ENVIRONMENTAL IMPACT ASSESSMENT OF THE PROPOSED WHITECOURT NEWSPRINT MILL

SUPPLEMENTAL

<u>Reference</u>: Environmental Impact Assessment for the Proposed Whitecourt Newsprint Mill - Supplemental

This supplemental report addresses questions outlined in correspondence from F.J. Schulte to R.N. Stern dated 15 July 1988. These questions were raised through the review process for the original Environmental Impact Assessment submitted 16 May 1988. This report was prepared by Nystrom, Lee, Kobayashi & Associates with assistance from several specialist consultants (Beak Associates Consulting Ltd., Cirrus Consultants, Associated Engineering Alberta Ltd., & The DPA Group Inc.) Additional correspondence is also provided pertaining to the public consultation process.

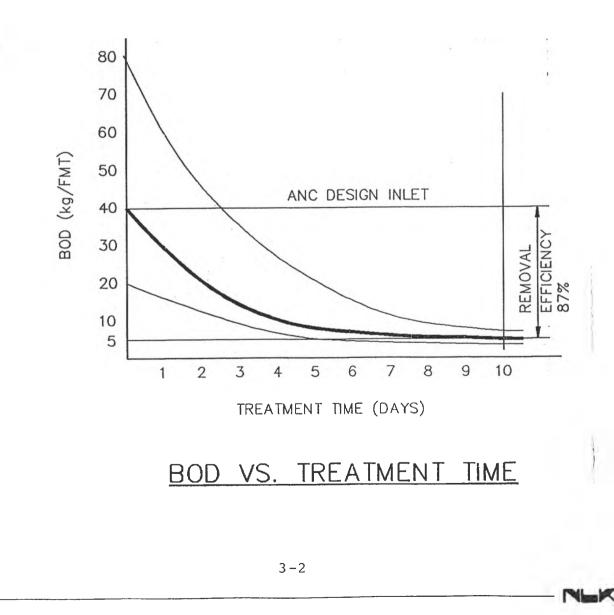
Please provide a graph and text comparing the anticipated range in BOD loadings entering the wastewater treatment system with the BOD_5 concentrations in the final effluent discharged. The range should include the worst case conditions as well as those customarily observed in the industry. Discuss what seasonal variation may be expected in effluent quality.

Typical response curves for BOD reduction versus treatment time are shown below. BOD is reduced rapidly at the start of treatment as easily degraded compounds are metabolized. As the effluent becomes more refractory the rate of BOD reduction diminishes.

The predicted raw effluent BOD_5 loading for the ANC plant configuration is 40 kg per FMT. A minimum BOD_5 removal efficiency of 87 percent is predicted to produce a final effluent with a BOD_5 loading not exceeding 5 kg per FMT.

The estimated raw BOD_5 loading of 40 kg per FMT is a conservative estimate based on the planned sodium sulphite treatment of 20 kg per FMT (as specified in the response to Question 20). In the worst case, raw BOD_5 might increase to a maximum of 50 kg per FMT. With a higher BOD loading, however, removal efficiency will be enhanced and treated BOD levels would not increase proportionately. Aeration capacity will be installed with adequate margin to handle maximum BOD loadings.

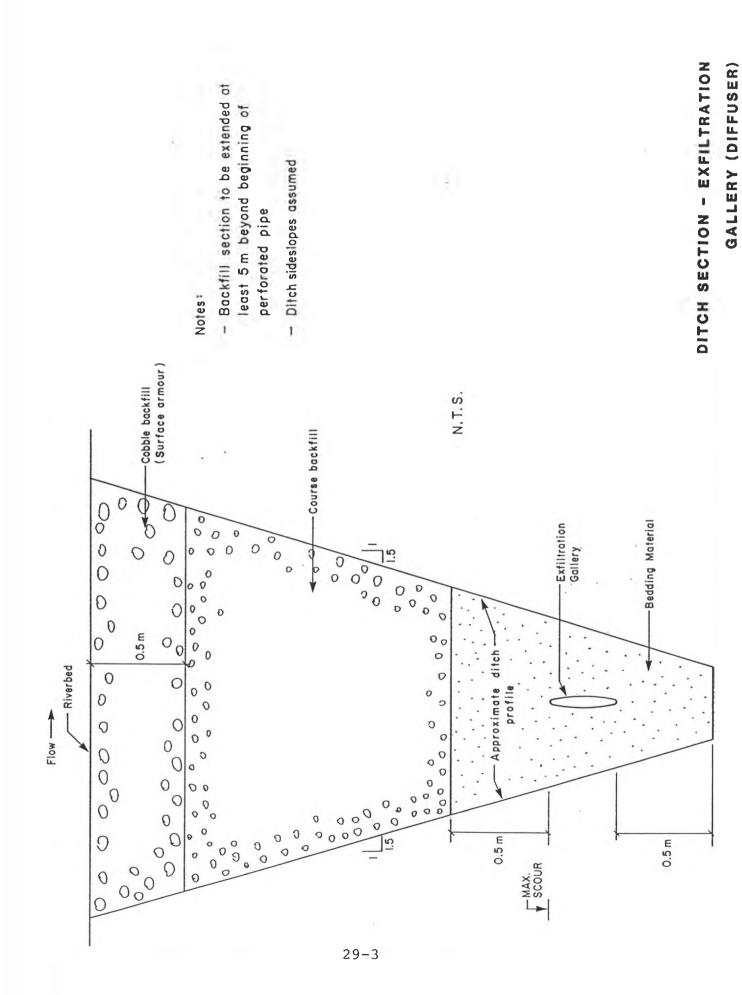
Provide further details on: (1) the effluent diffuser, and (2) the characteristics of the mixing zone. Provide quantitative estimates of the length of the mixing zone for a full range of river flows under open water and ice conditions. Describe how the estimates were calculated including assumptions made. Consider the effects that river morphology, notably the number of islands and side channels in the river below the site, will have on the size and shape of the mixing zone.

Mixing lengths for the ANC diffuser outfall have been estimated using methods outlined in Transverse Mixing in Natural Streams (Beltaos, 1978) and A Review of Analytical Equations for Two Dimensional Dispersion (Hodgson, 1986). For single channel flow conditions (i.e. flows less than 125 m^3/s) a diffuser which extends to midstream (such as ANC's) has the following mixing lengths:

Condition	Flow	Mixing Length	
	(m-/s)	(km)	
ice cover 7Q10	33.6	22	
ice cover	78	33	
open water	125	19

These estimates are based on single channel conditions. As the flow increases and occupies multiple channels, the mixing lengths will increase. However, due to the much higher flows, the amount of dilution achieved is superior even before compete mixing occurs. Complete vertical mixing is estimated to occur within 50 m downstream of the diffuser at the 7Q10. A dilution of 100:1 will be achieved at 20 m downstream at the 7Q10 flow.

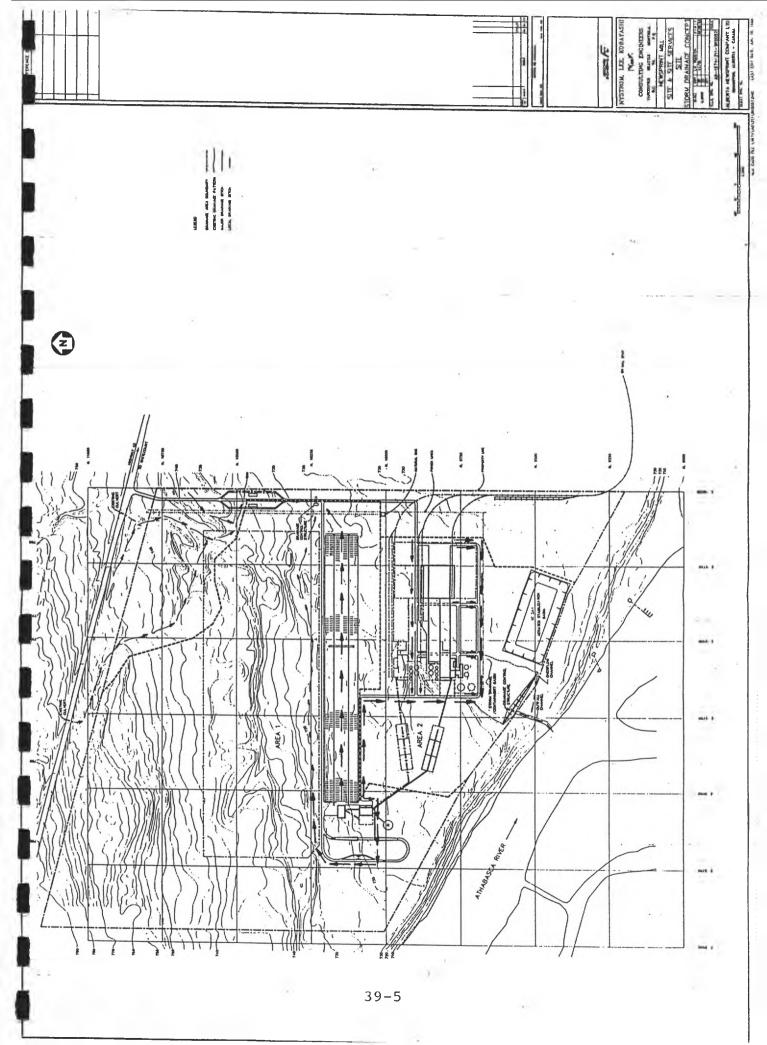
Please provide a conceptual water management and surface drainage plan for the site including the log storage and chip storage areas. Include information on the factors that will be considered in the design of any ponds or drainage structures. Identify pertinent approval processes as appropriate. Address the need to integrate surface drainage with the wastewater treatment system to prevent groundwater contamination or prevent contaminants such as wood resins from entering natural water courses.

A site surface drainage plan has been developed to effectively remove surface water from the site. The drainage pattern is outlined in Drawing AO-1674-211-SK0057.

All storm drainage will be collected in surface ditches and directed to the containment area. Culverts on short sections of stream sewers will only be used where space modification does not allow for the installation of open ditches and where ditches cross roadways, paved or large graded areas.

Area 1: $1.6 \text{ m}^3/\text{s}$ Area 2: $3.8 \text{ m}^3/\text{s}$ Total $5.4 \text{ m}^3/\text{s}$

FIGURE 44-1 MEAN WIND SPEED AND PERCENT FREQUENCY OCCURRENCE AT WHITECOURT, 1951-80

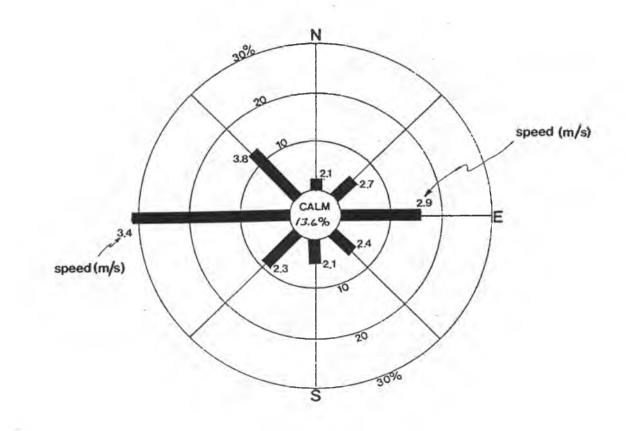
Provide a windrose and a STAR data summary for the Whitecourt area and discuss their implications for dispersion.

Wind patterns in the vicinity of Whitecourt, as contained in Table 2 of Appendix 2 of the Environmental Impact Assessment Report, were used to prepare the wind rose in Figure 44-1. The wind rose illustrates that westerly winds predominate with secondary maxima from the northwest and the east directions. These directions generally parallel the main topographic features of the Athabasca River Valley.

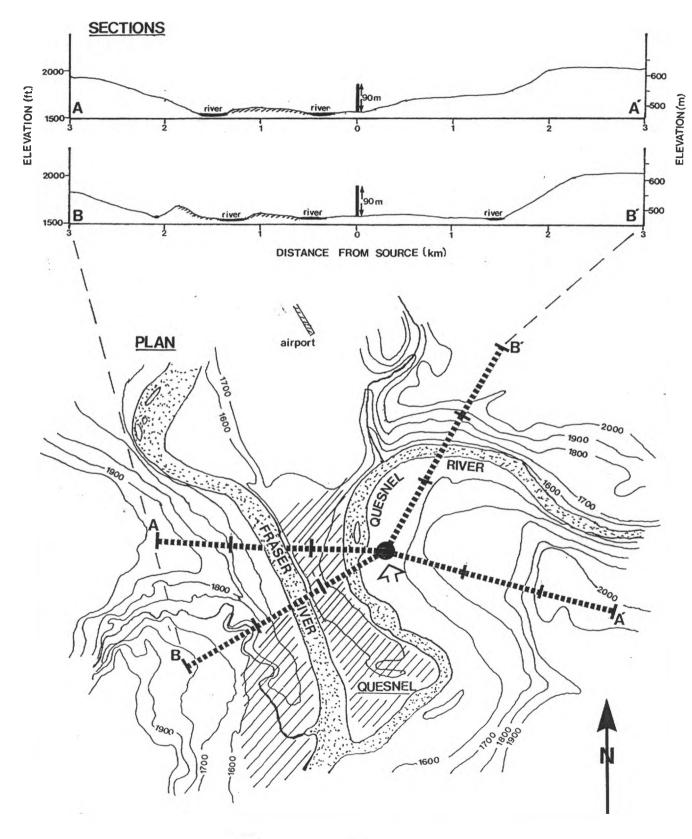
Please discuss how odour studies and fog studies at Quesnel, B.C. are applicable to this site (presumably there may be different emmission rates, different dispersion characteristics, different terrain and vegetation). Provide copies of any reports referenced.

The valley terrain is steeper at Quesnel than at Whitecourt, as illustrated in Figures 51-1 and 51-2 respectively.
